Nomad

SERVICE BULLETIN

WINGS — STRUTS — UPPER STRUT FITTING BOLT INSPECTION, LINE REAMING AND REPLACEMENT

NMD-57-19

Figure 6 Special Line Reamer — Strut Upper End Fitting

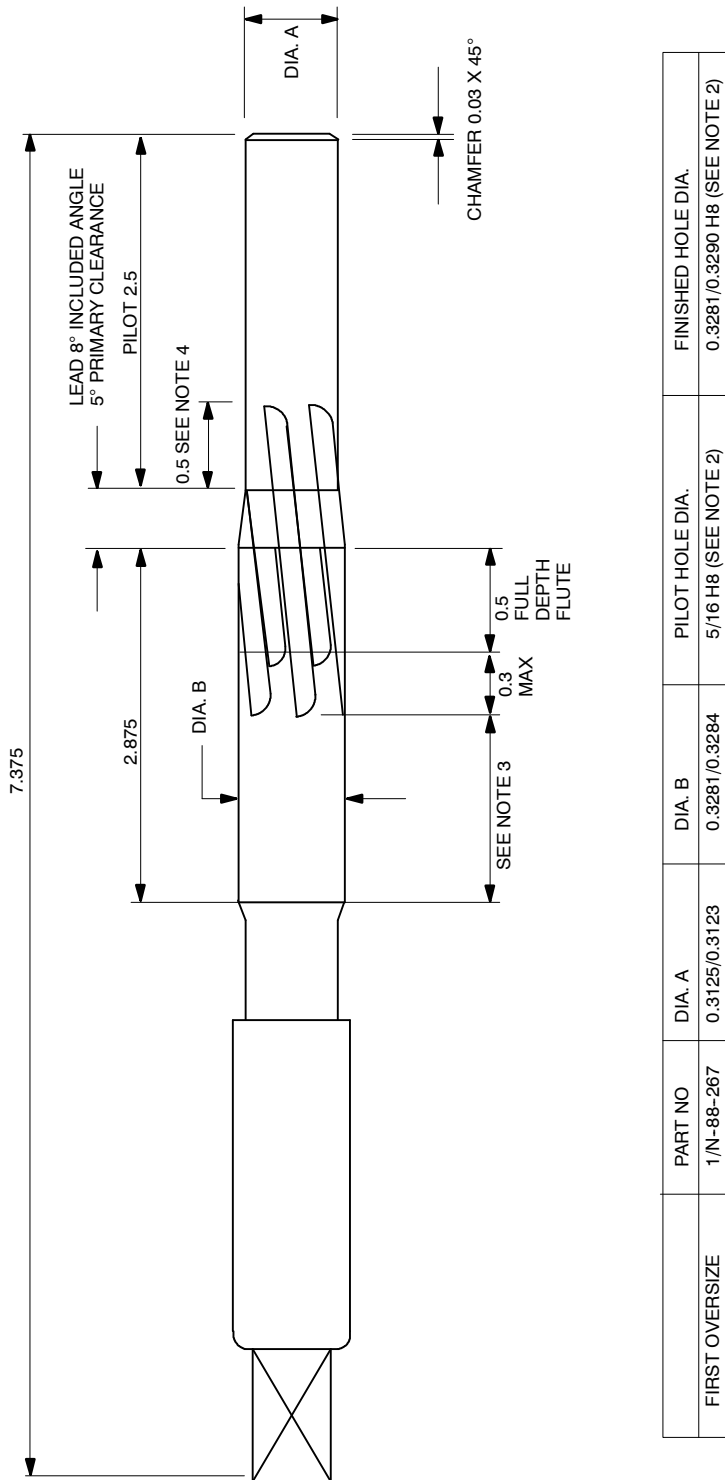
- (1) Special line reamer P/N 1/N-88-267 (1st oversize) is available for purchase or lease from ASTA, Nomad Support. Price is available on application, or
- (2) The special line reamer may be locally manufactured as per Figure 1.

- (3) Carefully line ream the hole to 1st oversize, with special line reamer Part Number 1/N-88-267 (Ref Fig.1).

- (1) Special Line Reamer Part Number 1/N-88-267 (Ref Fig 1).

- NOTES:
1. EXCEPT AS SHOWN, REAMER IS A HELICAL FLUTED (6 FLUTES) HAND REAMER MADE FROM HIGH SPEED STEEL - COMMERCIAL TO ANSI B 94.2-1964.
 2. FOLLOWING GRINDING, A TRIAL HOLE IN QQ-A-225/6 T 851 MATERIAL (PREVIOUSLY PILOT REAMED - REFER TABLE) IS TO BE REAMED USING SUITABLE LUBRICANT. FINISHED HOLE DIAMETER IS TO BE AS PER TABLE AND AT LEAST THREE FLUTES MUST BE SHARING THE CUTTING. REAMER TO BE RE-GROUND OR STONED UNTIL THESE CONDITIONS ARE MET.
 3. FLUTES NOT REQUIRED OVER THIS LENGTH. BACK TAPER NOT TO EXCEED LIMITS OF TOLERANCE ON DIA.
 4. NO CUTTING EDGES OVER THIS LENGTH.
